Wednesday, February 2, 2022
Planning Commission

Planning Commission Agenda

Subject **A. CONSTRUCTION STANDARDS 22-01. Proposed amendments to Policy 4.39 of the Construction Standards.**

To: Mayor and City Council
From: Chris Thompson P.E., Public Works Director
Date: February 15, 2022
Re: Ordinance Construction Standards Revision (22.01)

Volunteer Drive Connection, 300 E Connection & Proposed Roundabout

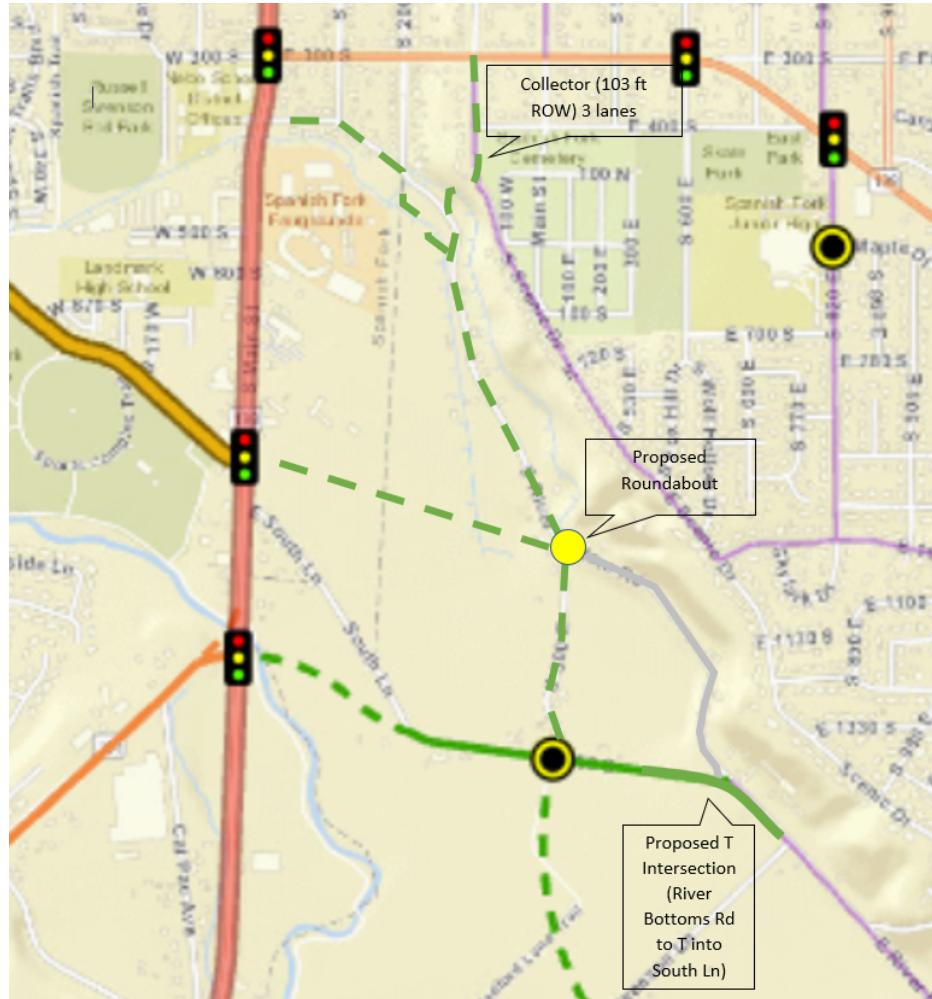
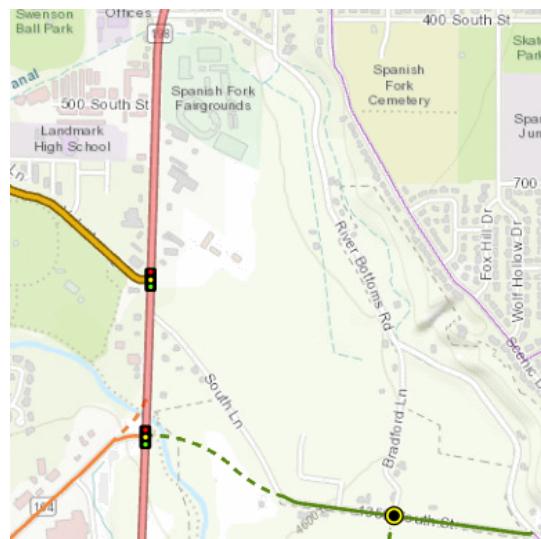
- South Ln and other roads in Annie's Acres area changed alignment, including addition of a roundabout
 - Upon approval, currently planned trails in this area will match new road alignments

Approve the revision to the Transportation Master Plan.

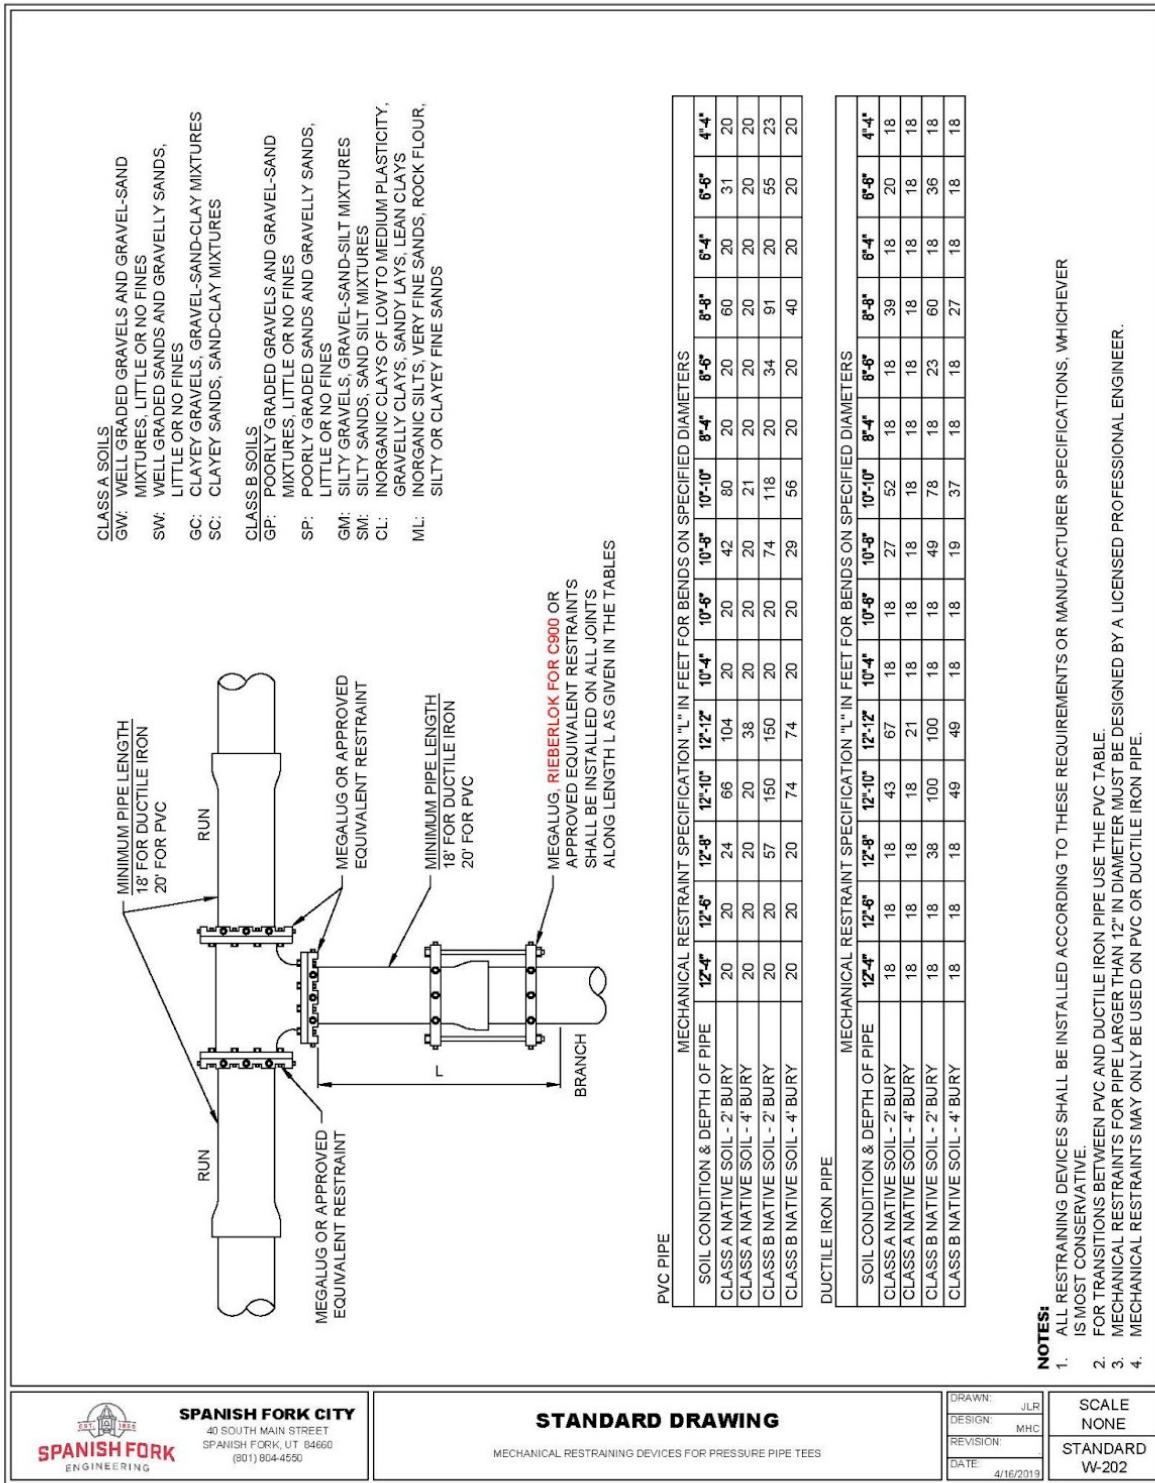
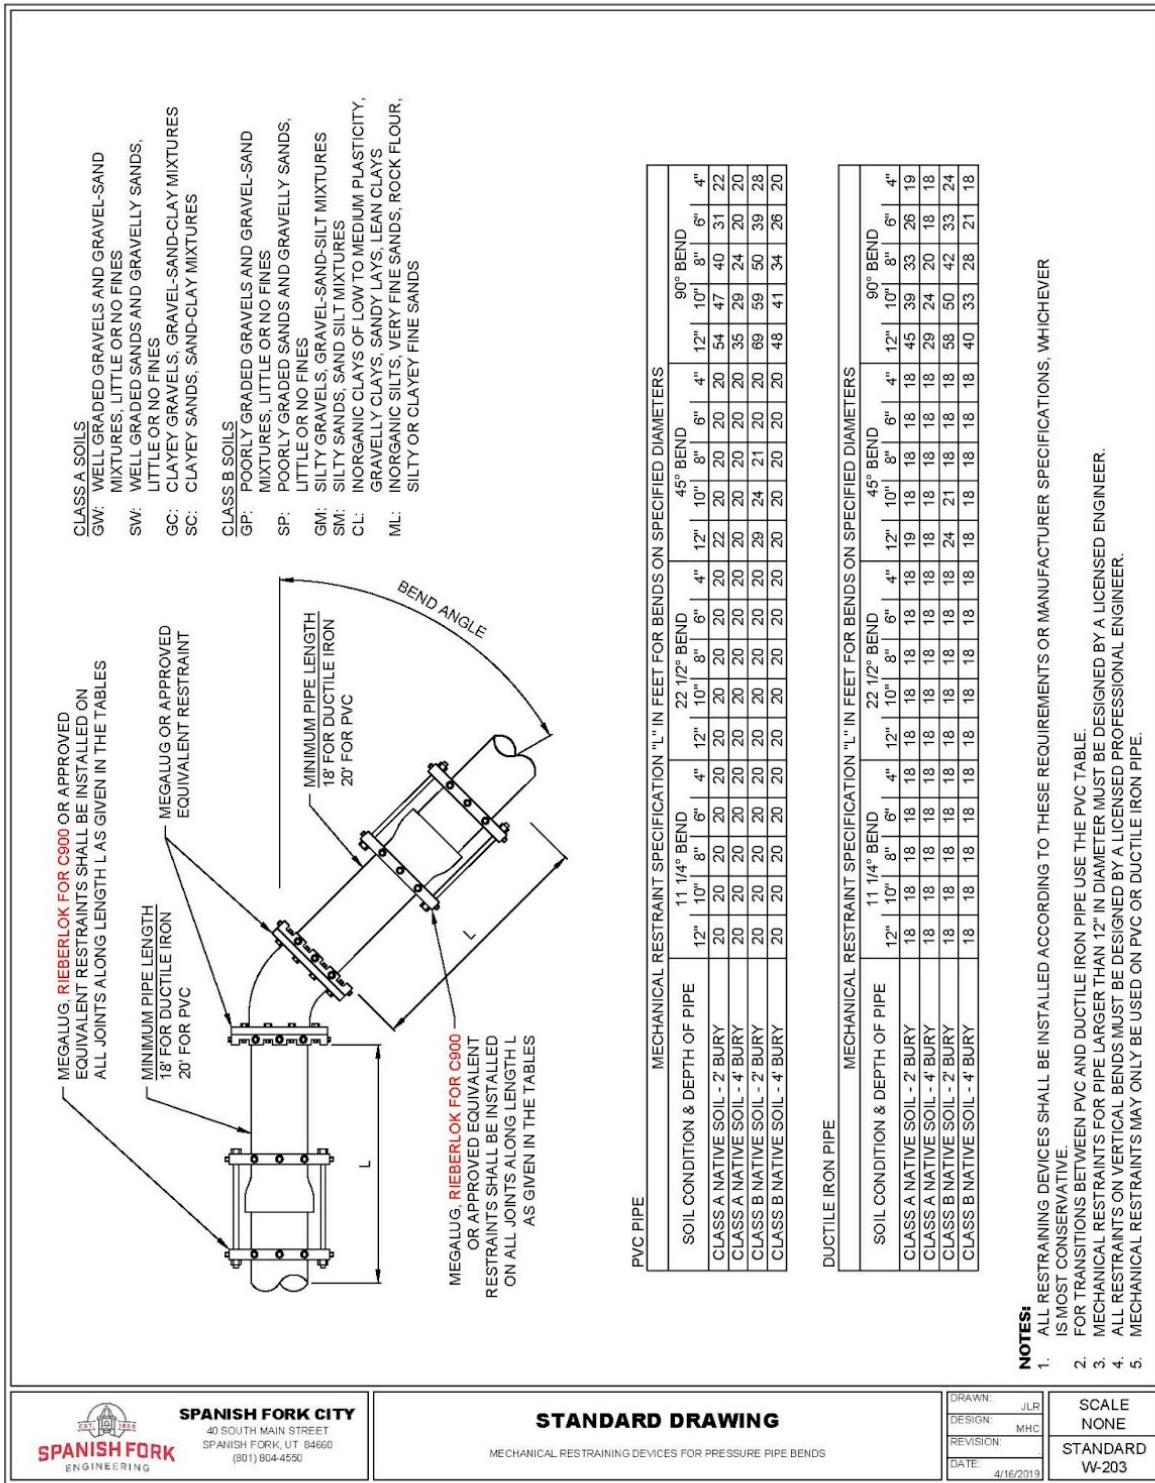
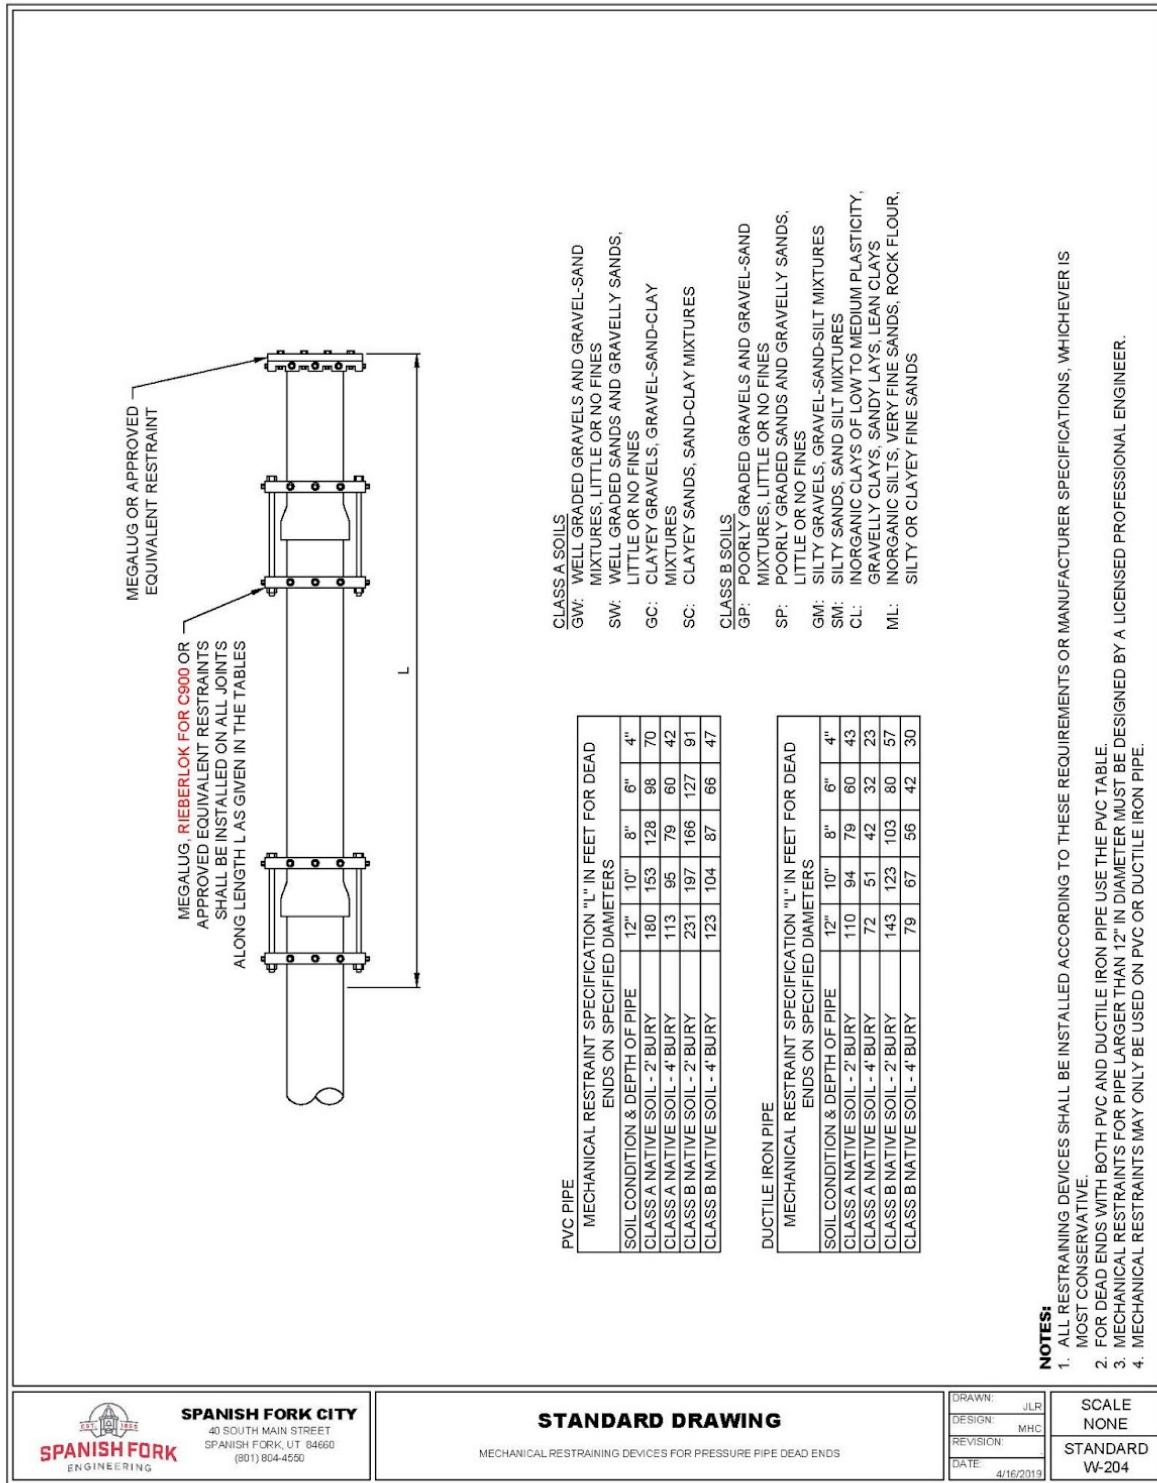
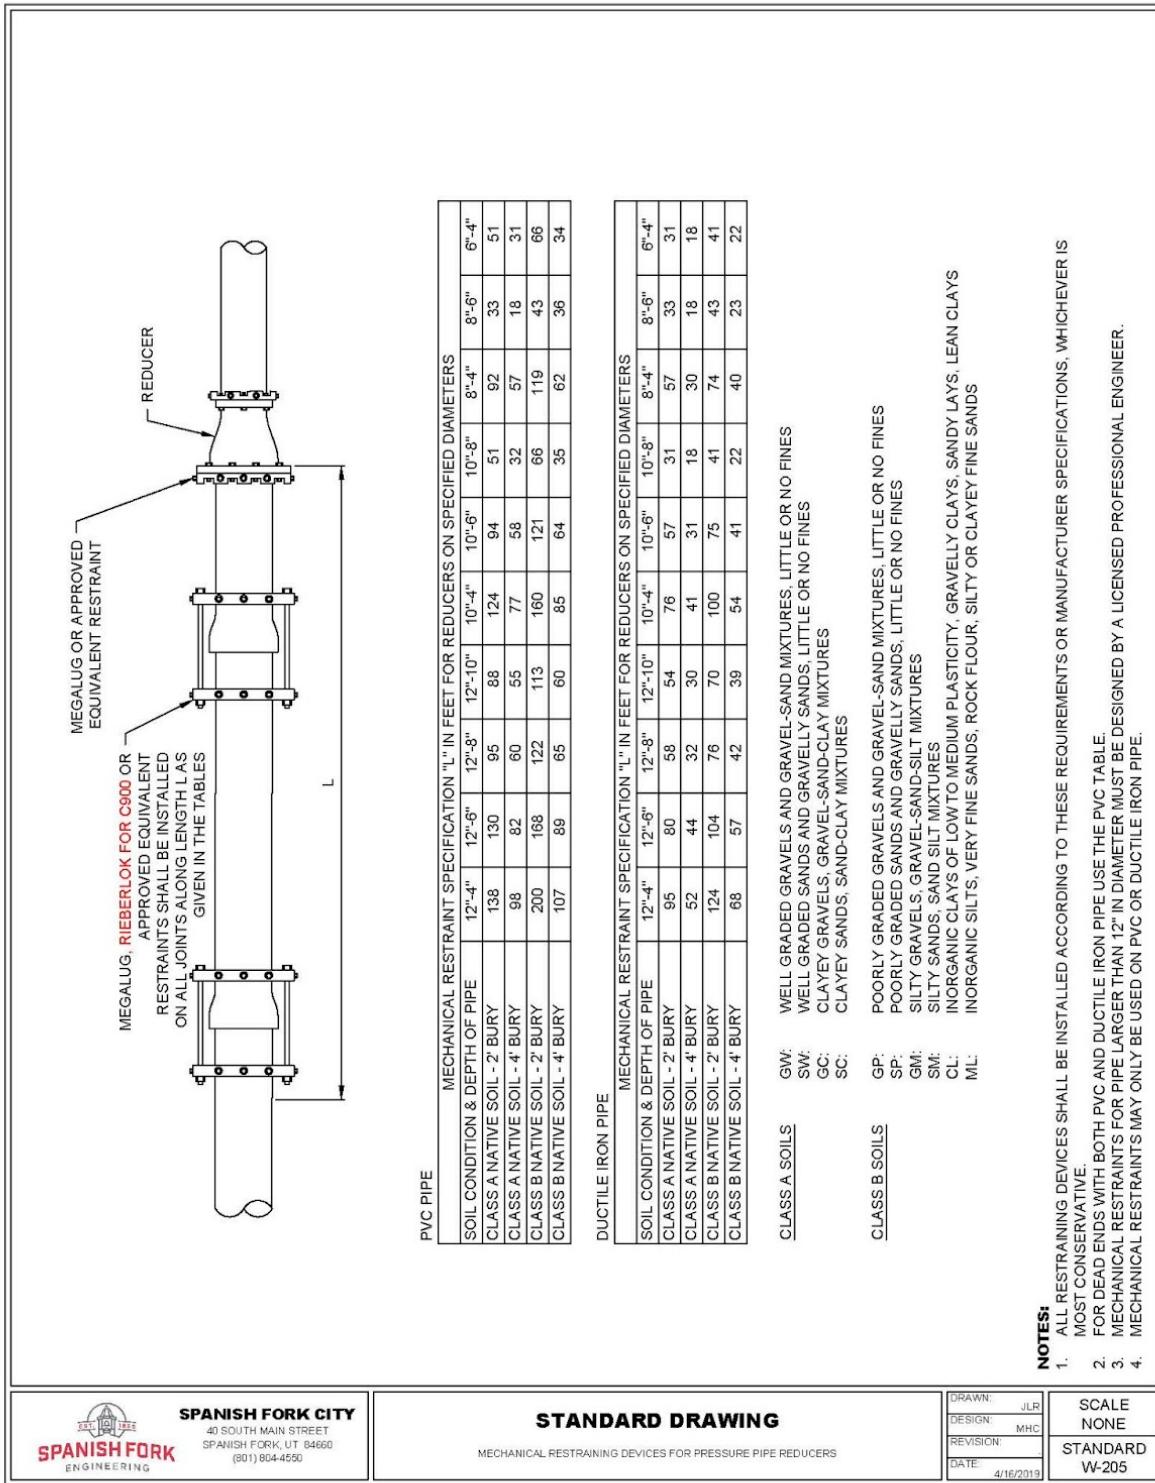
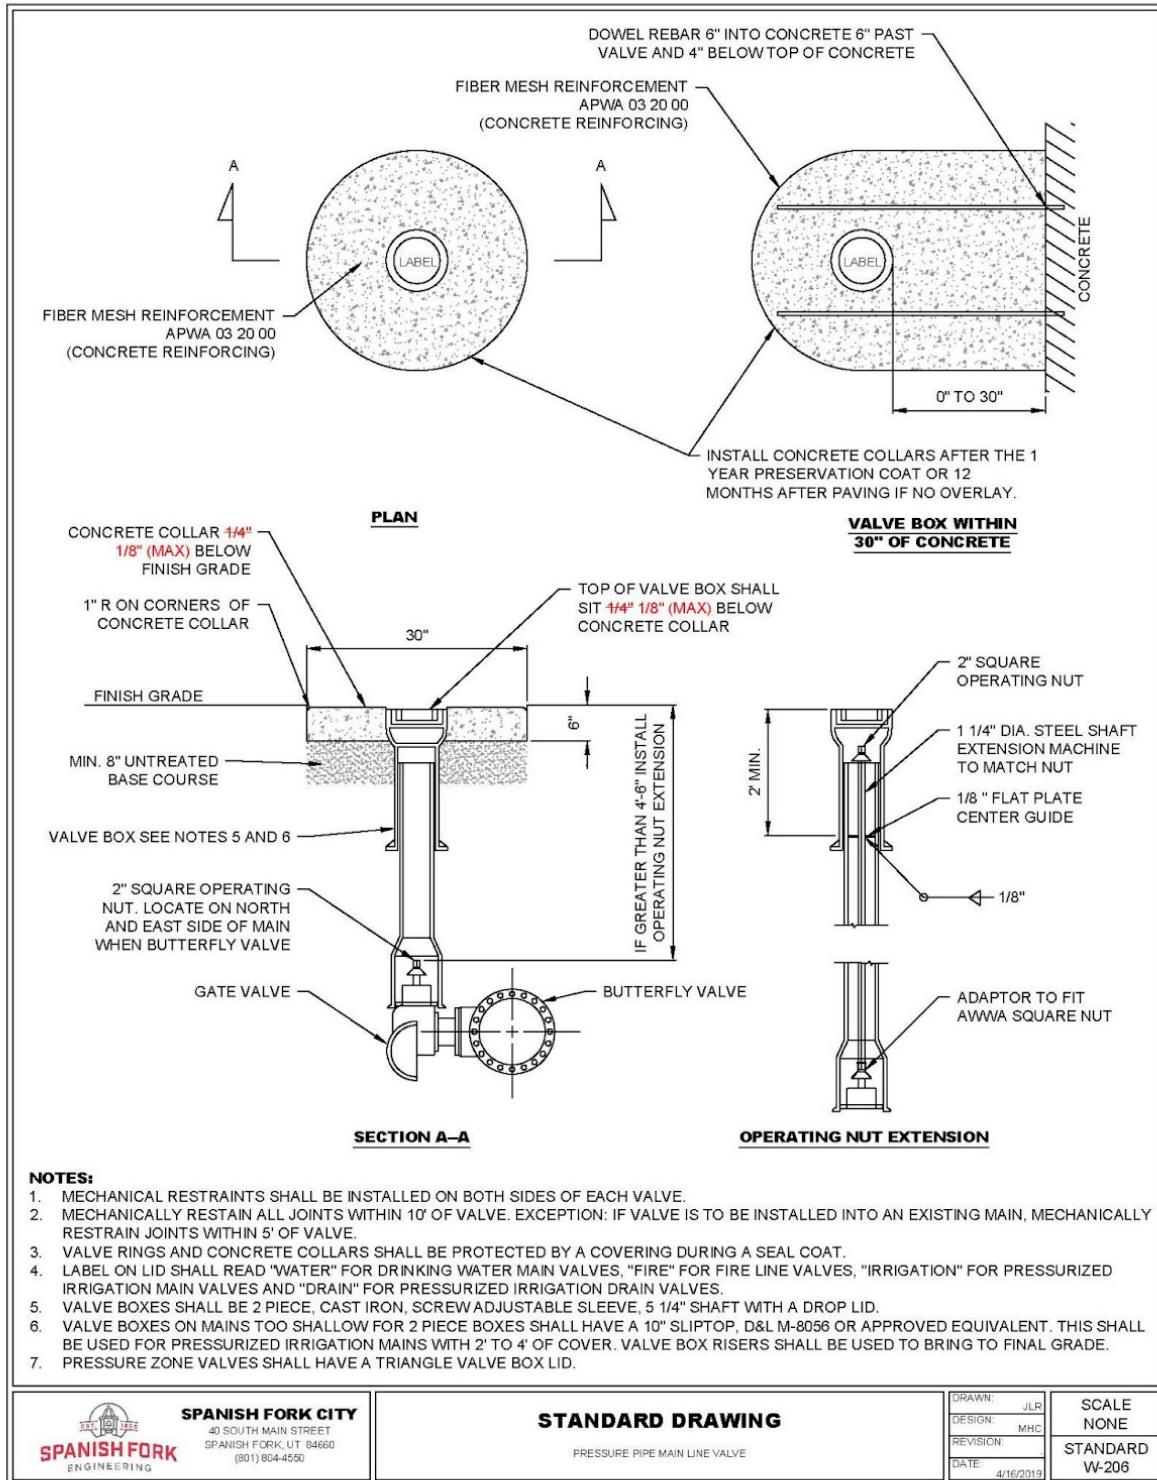
- Modifies standards W-214, W-215, W-218, W-219 & W-222 to call out the correct manhole lid.
- Modifies Concrete Collar to read $\frac{1}{8}$ " (max) instead of $\frac{1}{4}$ "
